## Oyster Point Marina West Basin Access Improvements (Contract 2024-04)

### ADDENDUM NO. 1 RESPONSE TO QUESTIONS

FROM: San Mateo County Harbor District

DATE 04-10-2024  
SHEET 5 OF 25  
**C-003**

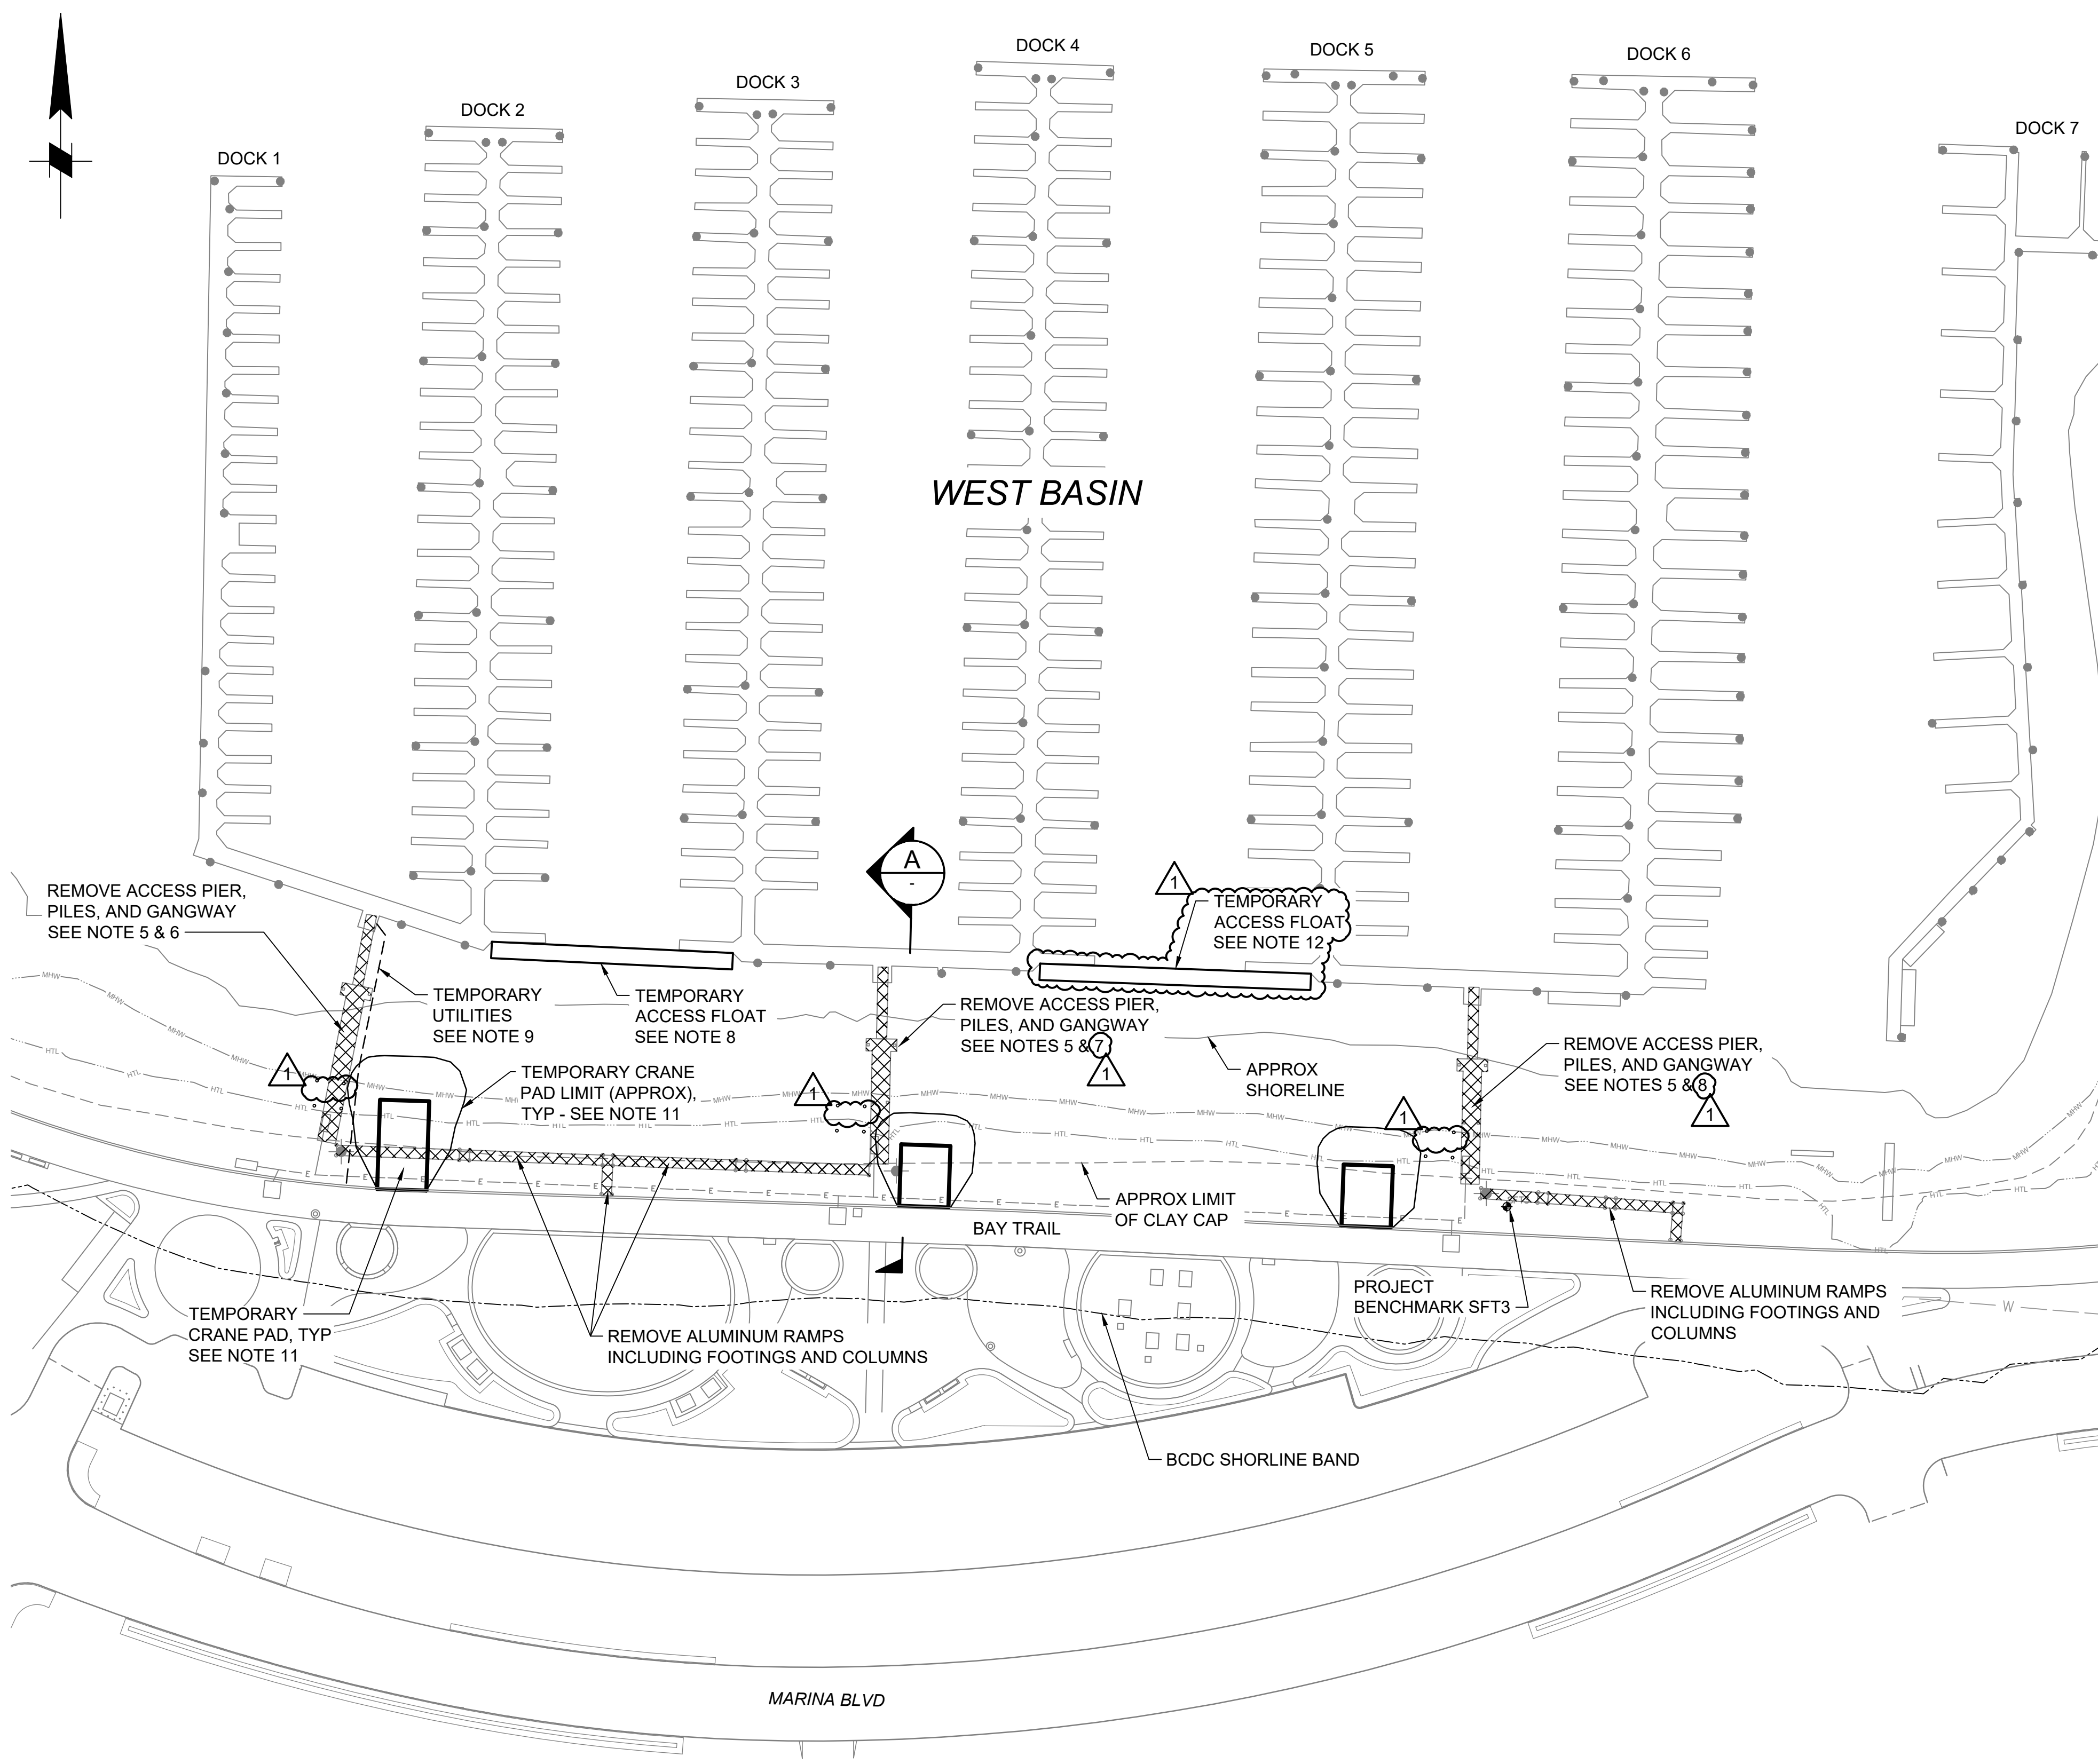
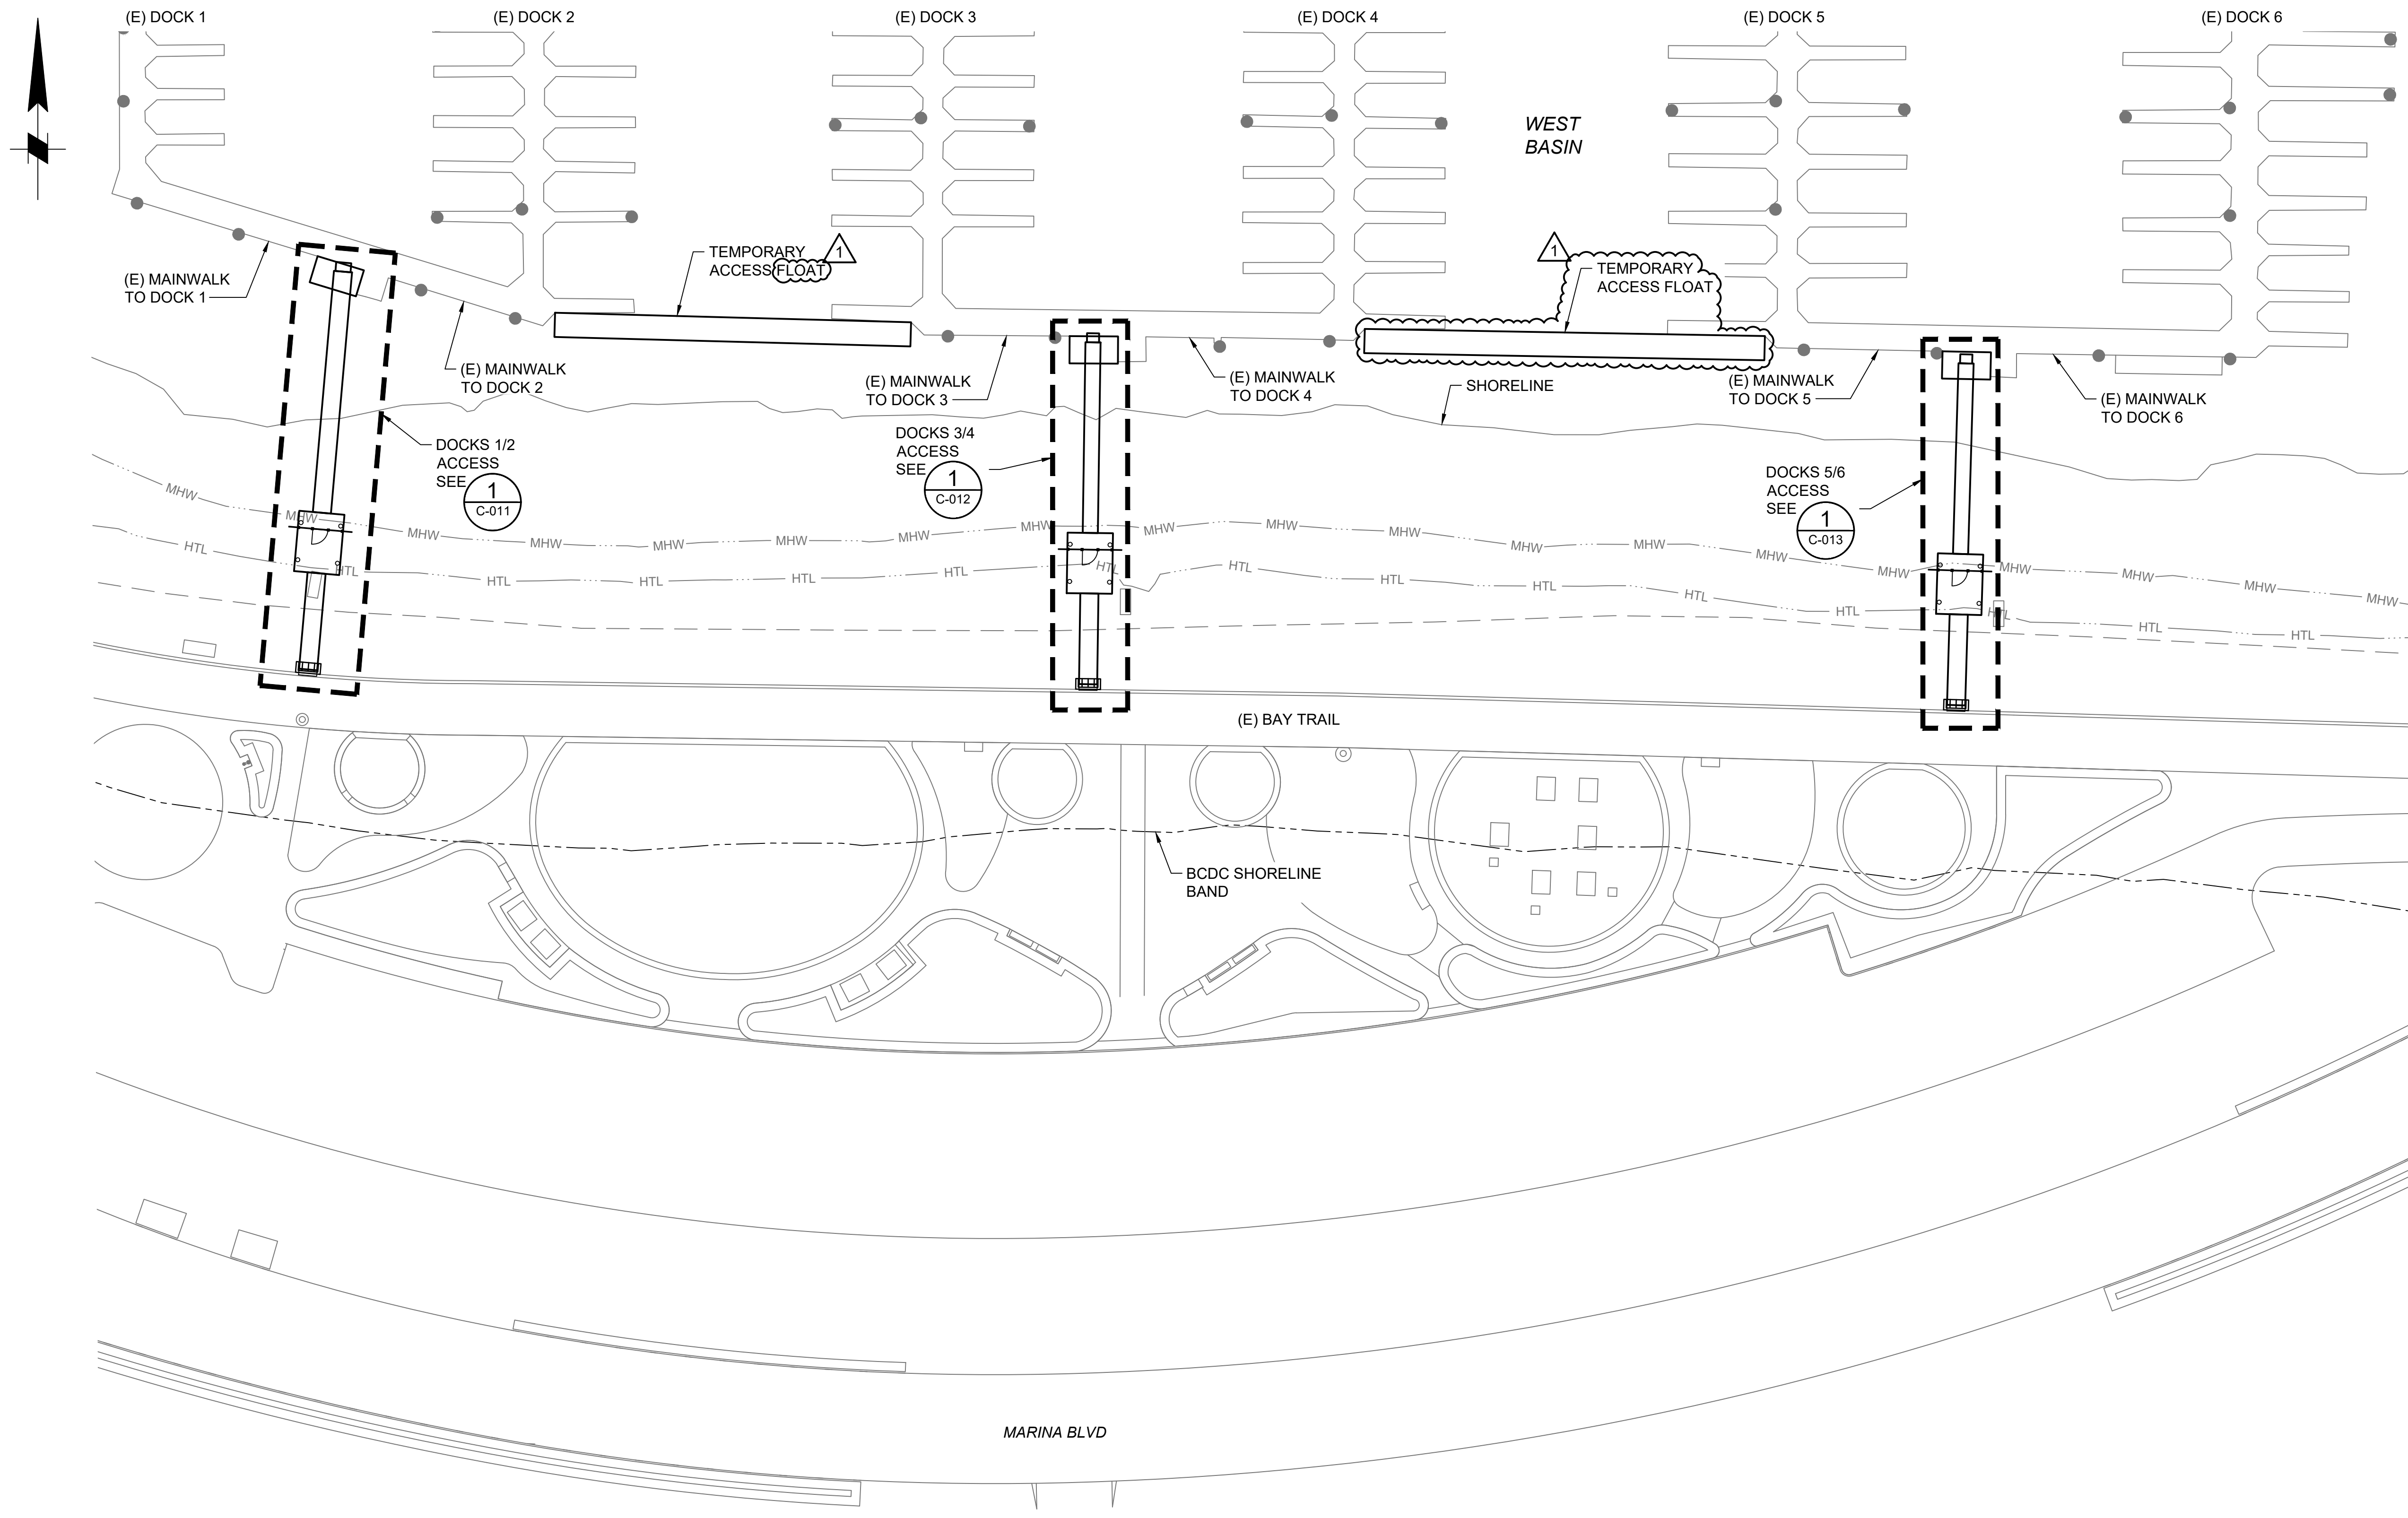
Question 13: Demolition (sheet C-003, note 5): Confirm type and size of piles to be demolished at docks 1/2, 3/4 and 5/6.

1. Plan View:
  - a. Add temporary access float between docks 4 and 5, and related note 12.
  - b. Delete proposed security gate and piles.
  - c. Revise callouts to reference correct notes.
  - d. Revise note 9.
2. Elevation View: Call out existing 12” concrete piles.

District response: For bidding purposes, assume the existing piles are 12" (nominal) square precast prestressed concrete.

8. DEMOLISH EXISTING ACCESS PLATFORM FOR DOCKS 5/6 AFTER CONSTRUCTION OF THE NEW ACCESS PLATFORM FOR DOCKS 5/6.
  9. PROVIDE 8' WIDE TEMPORARY FLOAT CONNECTING DOCK 2 AND DOCK 3 DURING CONSTRUCTION TO MAINTAIN ACCESS BETWEEN DOCKS 1/2 AND DOCKS 3/4.

12. IF REQUIRED, PROVIDE 8' WIDE TEMPORARY FLOAT CONNECTING DOCK 4 AND DOCK 5 DURING CONSTRUCTION TO MAINTAIN ACCESS BETWEEN DOCKS 3/4 AND 5/6.

DATE 04-10-2024  
SHEET 6 OF 25  
**C-010**

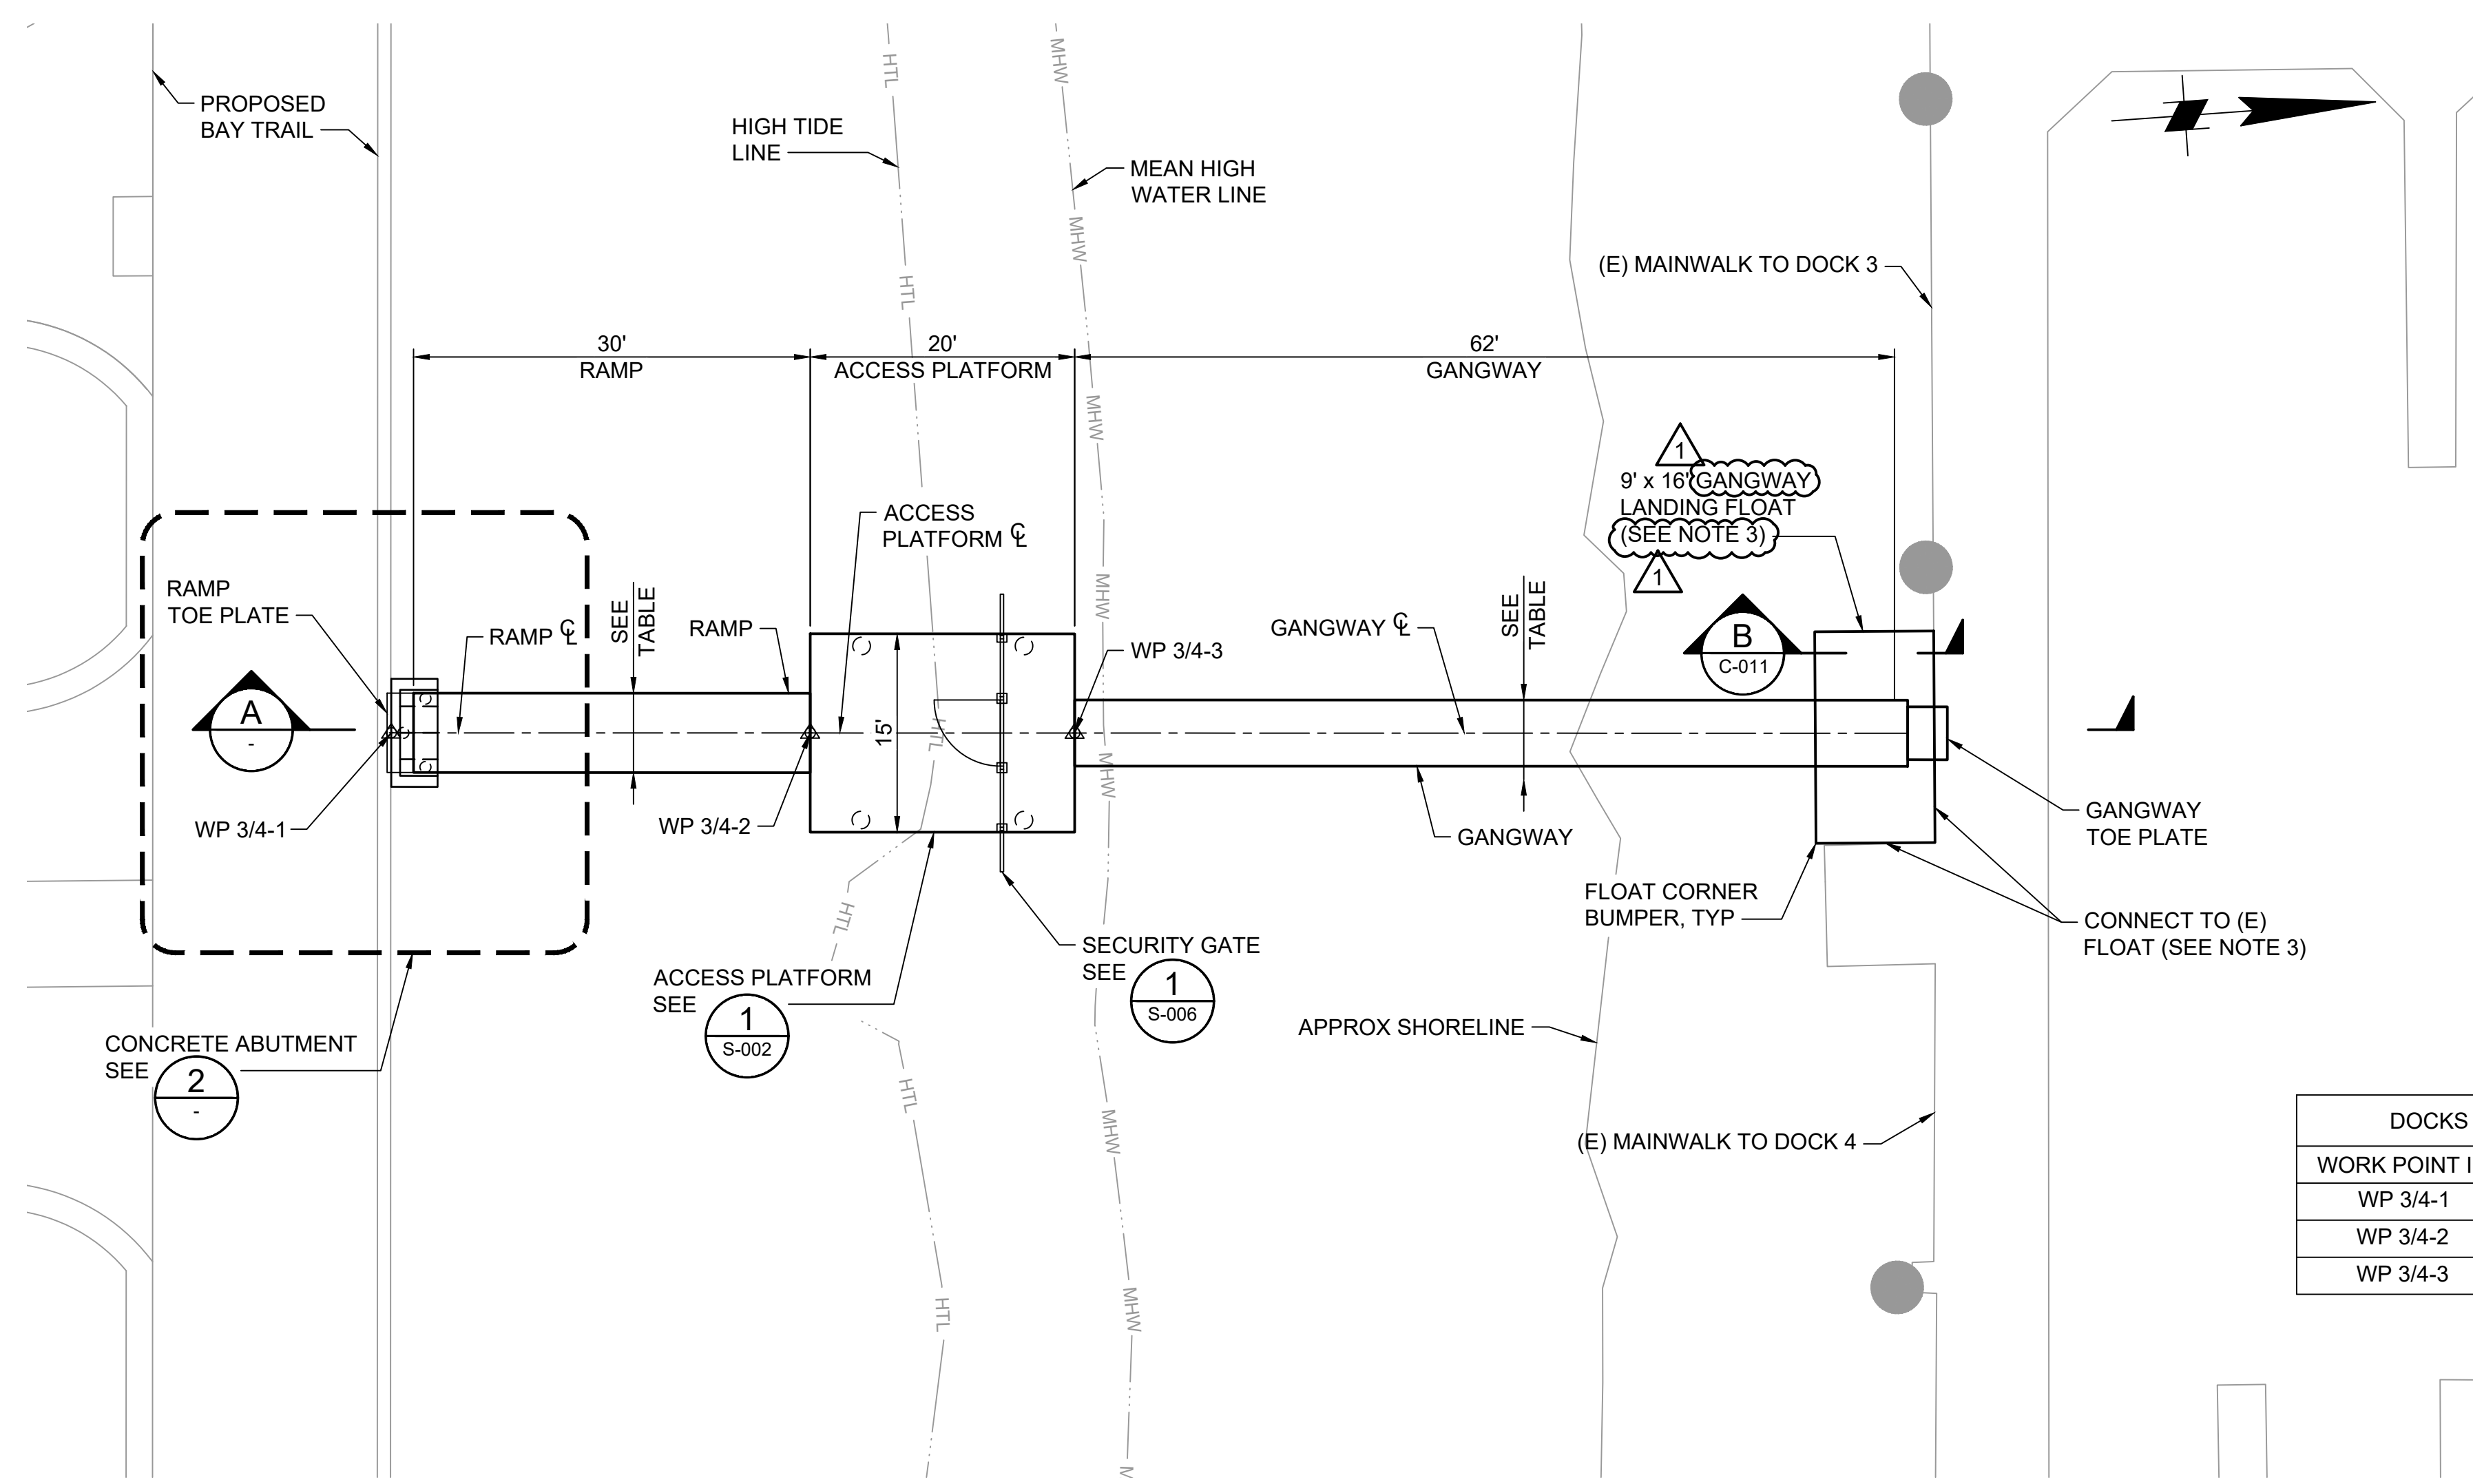
1. Plan View:
  - a. Add temporary access float between docks 4 and 5.
  - b. Revise “temporary access dock” to “temporary access float.”
